TECHNICAL EVALUATION REPORT  
ON THE ADEQUACY OF  
STATION ELECTRIC DISTRIBUTION SYSTEM VOLTAGES  
FOR THE VERMONT YANKEE NUCLEAR POWER STATION

(Docket No. 50-271)

September 3, 1982

FIGURE 1 VERMONT YANKEE NUCLEAR POWER STATION - ONE-LINE DIAGRAM

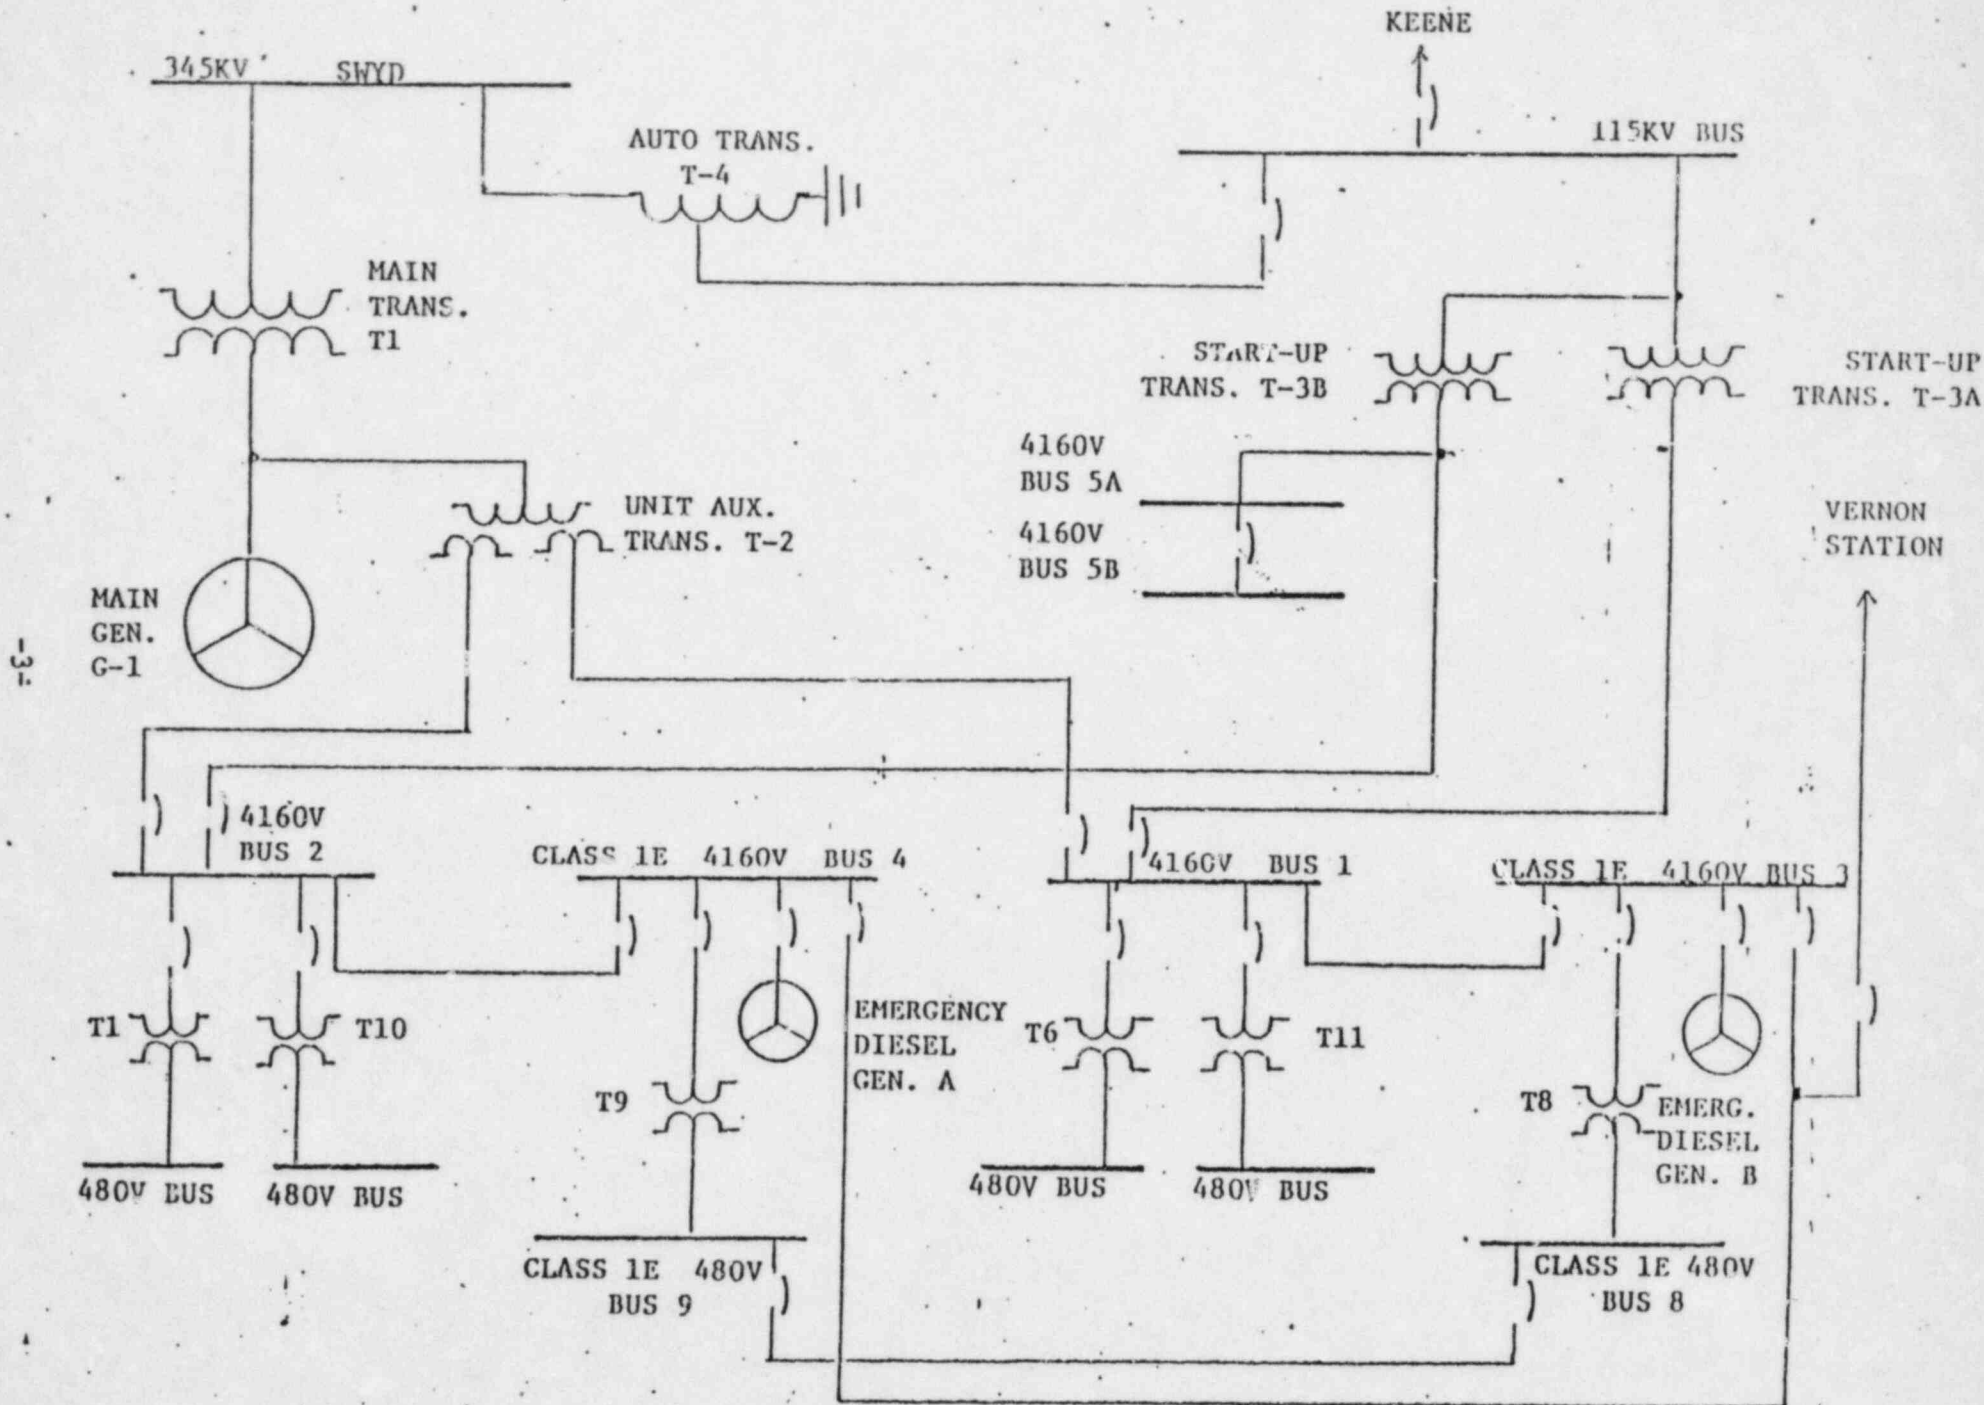
A one-line diagram of Vermont Yankee Nuclear Power Station's electrical distribution system is shown in Figure 1. This figure was adapted from Figures 2.1 through 2.5 of Reference 2. As shown in Figure 1, there are two 4160-volt Class 1E buses and two 480-volt Class 1E buses. During normal plant operation, 4160-volt Class 1E buses 3 and 4 are connected to station auxiliary buses 1 and 2, respectively. Auxiliary buses 1 and 2 are energized by unit auxiliary transformer T-2. The 480-volt Class 1E buses 8 and 9 are energized through station service transformer T-8 and station service transformer T-9, respectively. Upon loss of the main generator, buses 1 and 2 are automatically transferred to start-up transformers (SUT's) T-3A and T-3B, respectively.

The main generator is connected to the 345 kV switchyard through the main transformer T1. There are three lines which are connected to the 345 kV switchyard and one line connected to the 115 kV switchyard from which the startup transformers T-3A and T-3B are supplied. A 345/115 kV autotransformer connects the two switchyards together.

Protecting the Class 1E equipment from undervoltage conditions is accomplished by two levels of protection. The first level (loss-of-voltage) scheme which utilizes two relays on each 4160-volt Class 1E bus. The relays (2-out-of-2 logic) will operate in 1.25 seconds at zero voltage, 6.0 seconds at 41% of 4160 volts, and will not operate above 46% voltage. The second level scheme (proposed) also utilizes two relays per 4160-volt Class 1E bus in a 2-out-of-2 logic. These relays will have a setpoint of 3700 volts  $\pm$  40 volts (88.9%  $\pm$  1% of 4160 volts) with a time delay of 10 seconds  $\pm$  1 second.
